<u>SP-24-09</u>	<b>Staff Report – July 29, 2024</b>
<b>Application Type:</b>	Special Use Permit
<b>Project Address:</b>	1601 Lemoyne Avenue (Tax Map ID: 004.-05-03.0), 1611 Lemoyne Avenue To City Line, (Tax Map ID: 004.-05-02.0), 1585 Lemoyne Avenue (Tax Map ID: 004.-05-04.1)
<b>Summary of Proposed Action:</b>	<p>The applicant (Cuse Car Care, LLC.) proposes to change the land use from a heavy automobile repair use type to a light automobile repair use type and build a 2,920 SF (footprint) addition onto the existing building. The existing heavy automobile repair use type is a legal non-conforming land use in the Mixed-Use Transition, MX-3 Zone District. The light automobile repair use type is a conforming use and only permitted by a Special Use Permit in the MX-3 Zone District.</p> <p>The applicant also intends to combine three existing lots (1601 Lemoyne Ave., 1611 Lemoyne Ave., and 1585 Lemoyne Ave.) to become one new lot (new 1601 Lemoyne Ave.) for the proposed light automobile repair use and proposed building expansion.</p> <p>The total gross floor area of the proposed building is 5,840 SF (2-story) and the existing building is 3,165 SF (1 story). The total gross floor area of t

DRAWING DESCRIPTION  
**SITE PLANS**

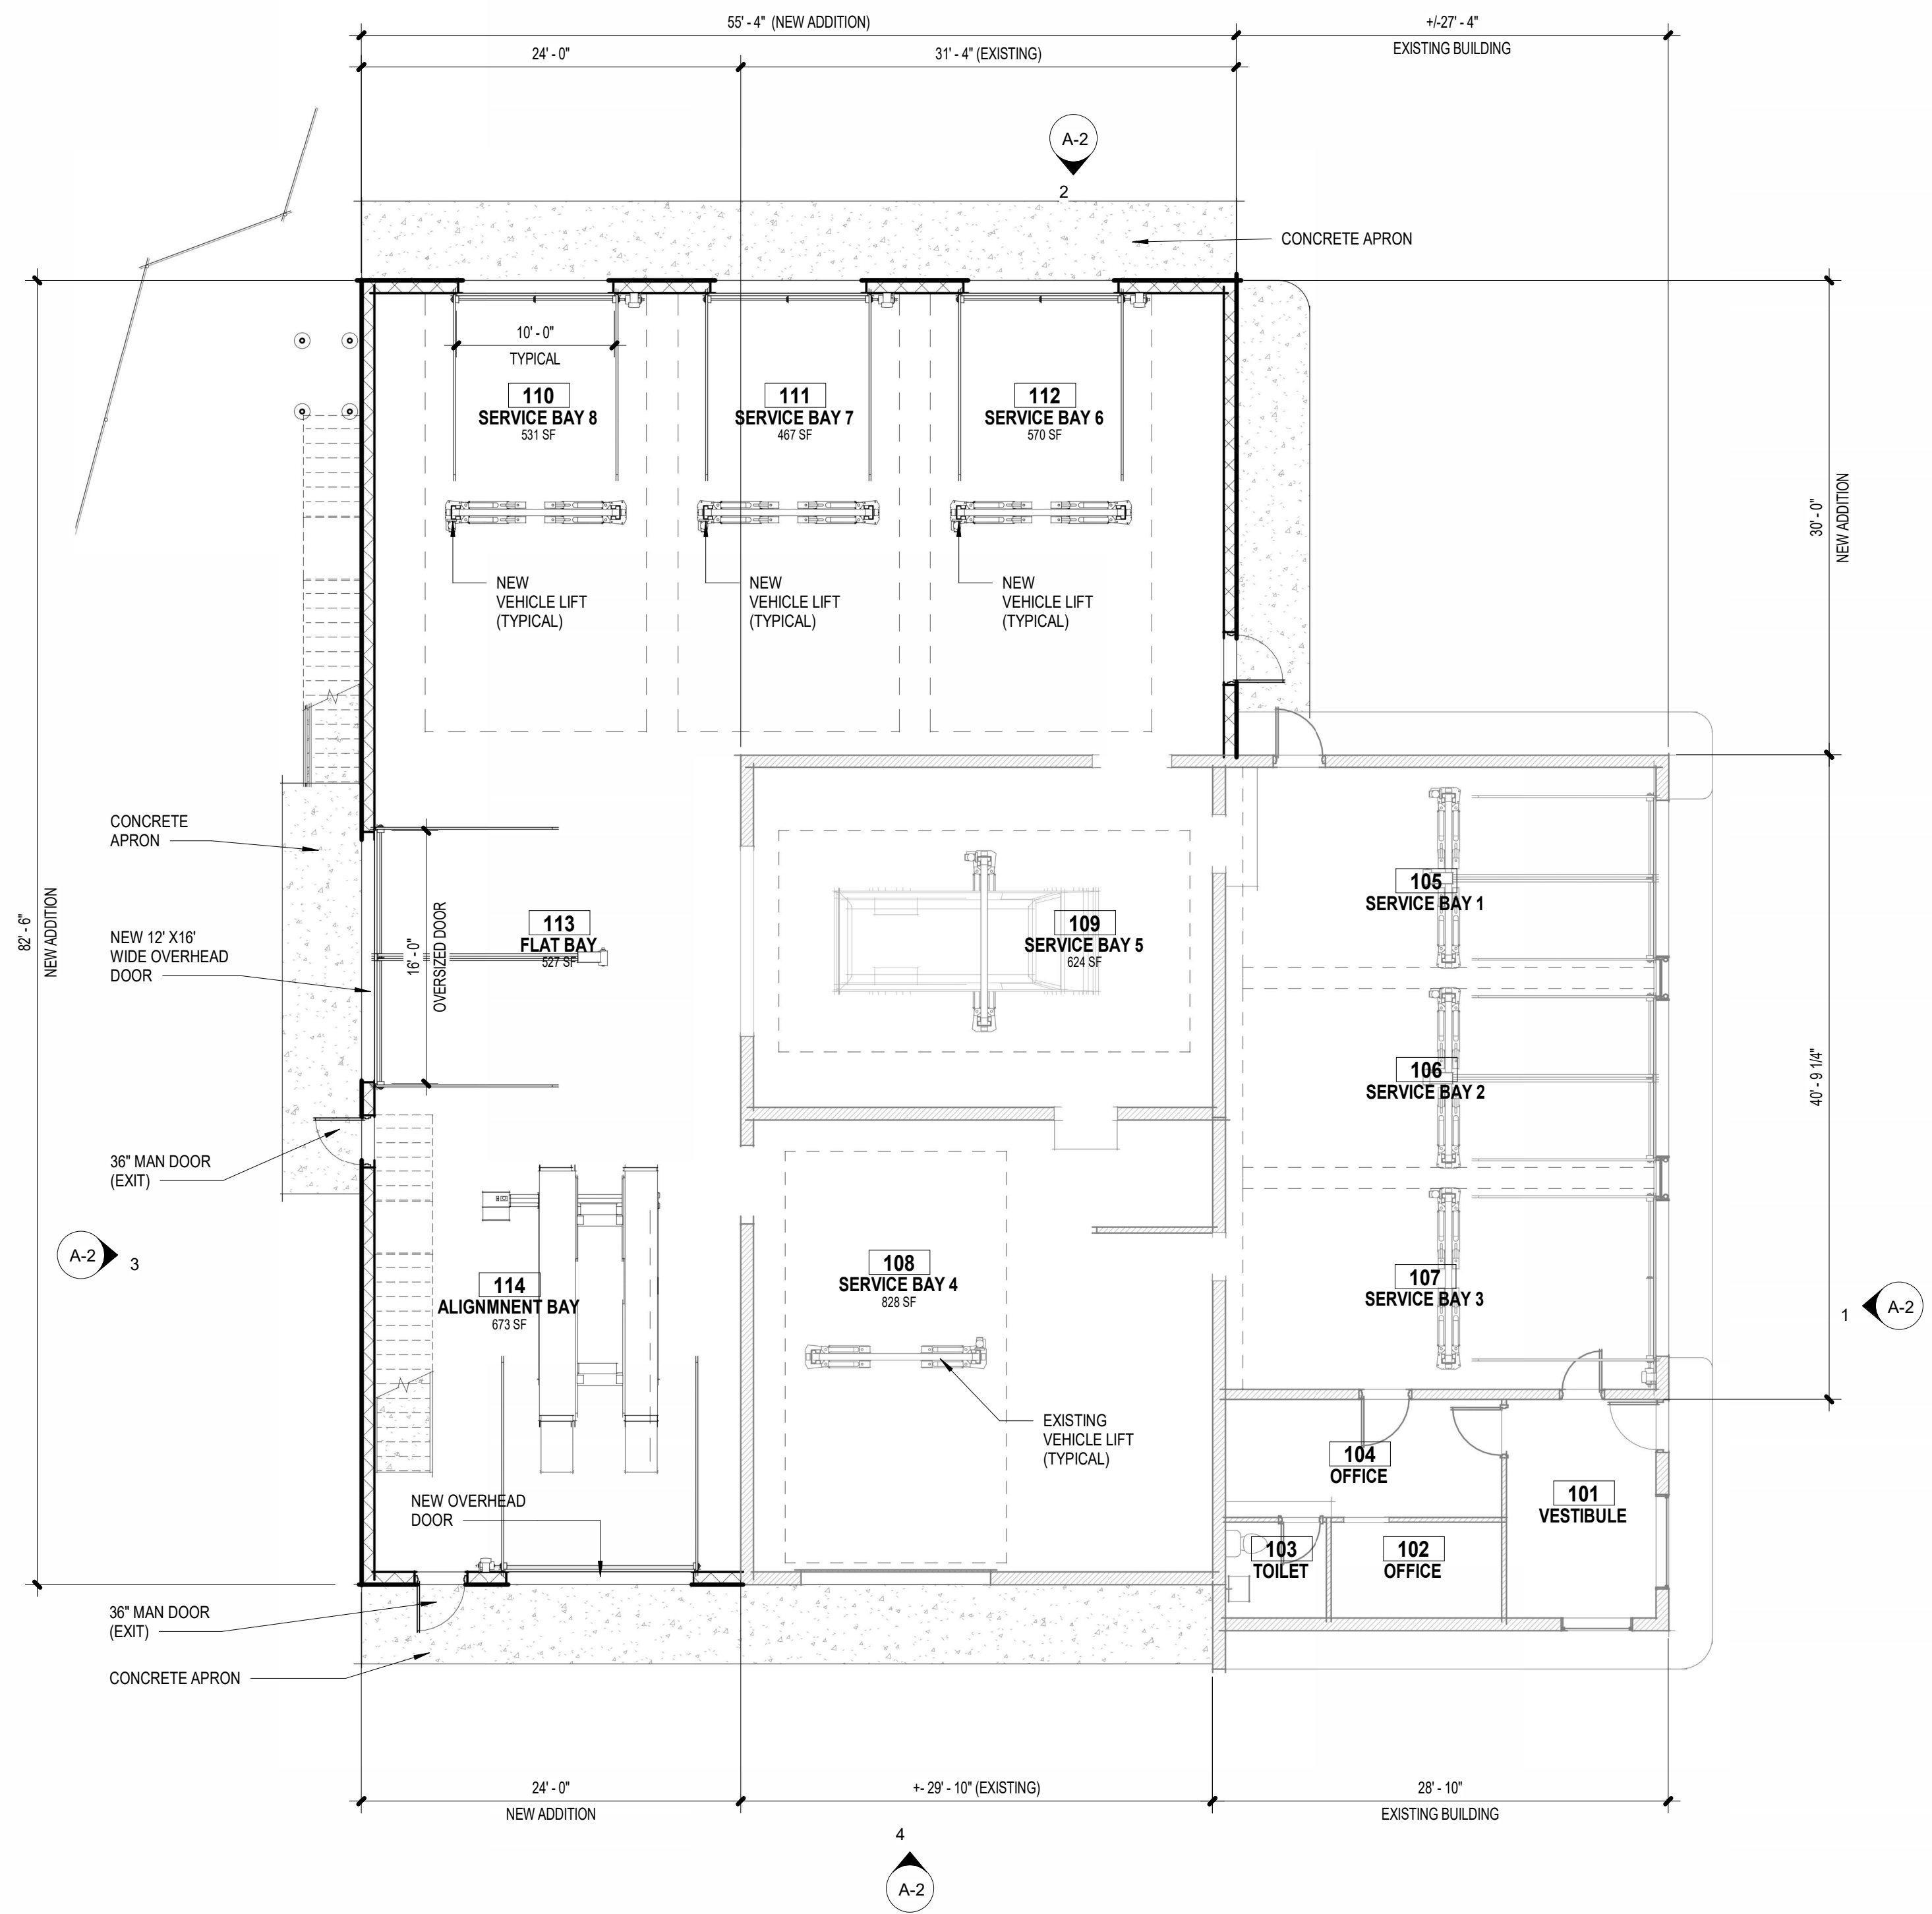
- WHEREAS, per the Site Plans, the applicant is proposing construction of a 2,920 sf 2-story addition to the northeastern and northwestern sides of the existing building which will allow construction of four new service bays in addition to the existing five bays, second floor offices, breakroom, and storage; gravel will be replaced with new asphalt, a dumpster enclosure constructed, and striping of 17 parking spaces along the southwestern and northeastern site boundaries; the Site Plans do not depict any changes in access to the site, plantings, or increase in permeable surface; and

will not result in additional stormwater; the Site Plan depicts 3 catch basins located in the parking lot; and

1. The applicant is required to coordinate with the Onondaga County Department of Transportation regarding access plans and establish formal driveway access to LeMoyne Avenue in conformance with commercial driveway standards. The municipality must ensure any mitigation as may be determined by the Department is reflected on the project plans prior to, or as a condition of, municipal approval.
2. The applicant and City must coordinate a multi-municipal review of the proposed project with the Town of Salina.
3. The applicant and municipality are encouraged to improve appearance of the

site while improving stormwater conditions by adding landscaping and plantings along the road frontage and parcel boundaries, adding bioswales and planting islands, and/or utilizing permeable pavement on site.

1. The applicant is required to coordinate with the Onondaga County Department of Transportation regarding access plans and establish formal driveway access to LeMoyne Avenue in conformance with commercial driveway standards. The municipality must ensure any mitigation as may be determined by the Department is reflected on the project plans prior to, or as a condition of, municipal approval.
2. The applicant and City must coordinate a multi-municipal review of the proposed Site Plan with the Town of Salina.

The applicant and municipality are encouraged to improve appearance of the site while improving stormwater conditions by adding landscaping and plantings along the road frontage and parcel boundaries, adding bioswales and planting islands, and/or utilizing permeable pavement on site.

Approval	Status	Status Date	Reviewer	Comments
DPW - Transportation Planner	Conditionally Approved	06/25/2024	Neil Milcarek-Burke	<p>Revised plans address previous comments.</p> <ul style="list-style-type: none"> <li>- Applicant to ensure that cross access with neighboring parcels is restricted unless agreement in place, and parking areas along southern property line incorporate bollards or other fixed objects (no wheel stops) to prevent parking on grass.</li> </ul> <p>Revised plans required. Current site is hazardous to pedestrians and other traveling public due to lack of channelization for vehicle ingress/egress at a high-volume signalized intersection of an Arterial and Major Collector.</p> <ul style="list-style-type: none"> <li>- Parcel to conform to 24' max width curb-cut, current site plan shows ~120' feet total curb-cut. All other areas outside typical 24' opening to be restored to full reveal granite curb.</li> <li>- Concrete sidewalk required required across Lemoyne Ave frontage, including across driveway. Walk to be located at property line.</li> <li>- Asphalt is not a permissible ground cover material in the ROW, all asphalt in the ROW is to be removed and area restored to topsoil &amp; grass, outside of revised driveway opening. Area between sidewalk and curbline should be grass, and incorporate any requirements per Forestry Department.</li> <li>- Parking area/lot frontage to incorporate a guide rail or other fixed vertical objects (no wheel stops), other than</li> </ul>

- Parking area to be curbed/incorporate fixed vertical objects (no wheel stops) along all sides.
- Parking area to incorporate greenspace buffer, 5' or greater along entirety of Lemoyne ave frontage outside of driveway opening, measured inwards from property line. To include perirenal plant material/trees/etc.
- Planting plan required, grading/drainage plan may impact/increase buffer requirements.
- ADA compliant walkway to/from the main entrance and public ROW/sidewalk required, typically aligned with loading area of accessible parking stalls.

DPW - Sanitation & Sewers	On Hold	04/17/2024	Vinny Esposito	<p>please provide a drainage plan, The site will be nearly 100% impervious as per plan. Storm water must be mediated to an extent, dry wells or re-charge trenches. Also the sewer in the 20' ROW must be located precisely as I believe this is a 30" storm sewer.</p>
DPW - Traffic Control	Conditionally	04/23/2024	Charles	4.23.24 Conditionally Approved.

Approved		Gafrancesco	No sidewalk closures or obstructions or road or lane closures will be allowed as part of this work unless accompanied by MUTCD compliant detour.
Zoning Planner	On Hold	04/17/2024	Haohui Pan	Updated plan needs: The east side of the building that abutting the adjacent Residential Zone shall be fenced.
Engineering - Stormwater (SWPPP)	Conditionally Approved	04/25/2024	Mirza Malkoc	<ul style="list-style-type: none"> <li>• All construction in the R.O.W. will require a road cut permit, all construction in the R.O.W. to be per City standards and specifications.</li> <li>• Complete set of the stamped engineering site plans with specific details are required to complete a detailed project permit review.</li> <li>• Designer shall clearly indicate on the site plans how much soil disturbance this project will create. If the soil disturbance is over 10,000sf then a SWPPP is required but if the soil disturbance is less than 10,000sf then the designer need to do some improvements to the site by capturing the stormwater sheet flow and treating it before discharging it to the City's ROW.</li> <li>• Proposed grading shall be graded to prevent stormwater sheet flow to adjoining properties &amp; to the City R.O.W.</li> <li>• The Project is subject to Onondaga County's 1:1 offset. The City requires an offset plan &amp; details for review. Applicant shall submit sanitary flow data to the Engineering Department, the determined offset plan then most likely will require Common Council Approval.</li> <li>• Onondaga County Plumbing Control shall review and approve the plans as well.</li> </ul>
